ADD2014-00076 Lee County ePlan

RE: Cypress Walk (FKA Cobblestone)
ADD2014-00076

Enclosed please find responses to your insufficiency letter dated May 7, 2014. The following information has been provided to assist in the review and approval:

⚠4:1 TYPICAL LAKE CROSS SECTION
(SEE PLANS WHERE APPLICABLE) NTS

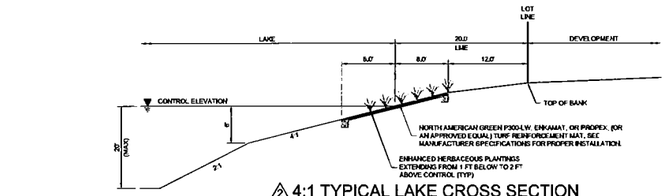
4. Deviation request #2: From 10-329(d)(4): Lake bank slopes to 4:1. Note that it is unclear where the 4:1 slopes are proposed. Please revise the plans to reflect the scope of the steeper slopes. Staff finds no compelling reason to support a deviation request where the property is vacant and undeveloped. Please clarify and enhance your deviation justification.

2. Requested Deviation #2 Lake Bank Slopes—please indicate on the MCP where the TRM's are being proposed. The TRM's are pending approval by the Development Services Director to deviate to 4:1 slopes.

3. Requested Deviation #2 Lake Bank Slopes—please provide a proposal for enhanced littoral shelf per LDC 10-329(d) (4). This of course is pending approval by the Development Services Director to deviate to 4:1 slopes.

RESPONSE: While the property is vacant it is constrained by existing conservation easements and preserve areas. In accordance with the cross section on the revised MCP, herbaceous plants are provided along all TRMs. As shown on the landscape plans submitted with the companion Development Order application (DOS2005-00341), the herbaceous plants are proposed in addition to the required littoral plantings per the LDC and Condition 16. This enhancement meets the intent of LDC Section 10-329(d) to mitigate erosion in support of the 4:1 lake bank slope.

RESPONSE: The TRMs are shown in hatching along the applicable lake bank slopes.

RESPONSE: In accordance with the cross section on the revised MCP, herbaceous plants are provided along all TRMs. As shown on the landscape plans submitted with the companion Development Order application (DOS2005-00341), the herbaceous plants are proposed in addition to the required littoral plantings per the LDC and Condition 16. This enhancement meets the intent of LDC Section 10-329(d) to mitigate erosion.
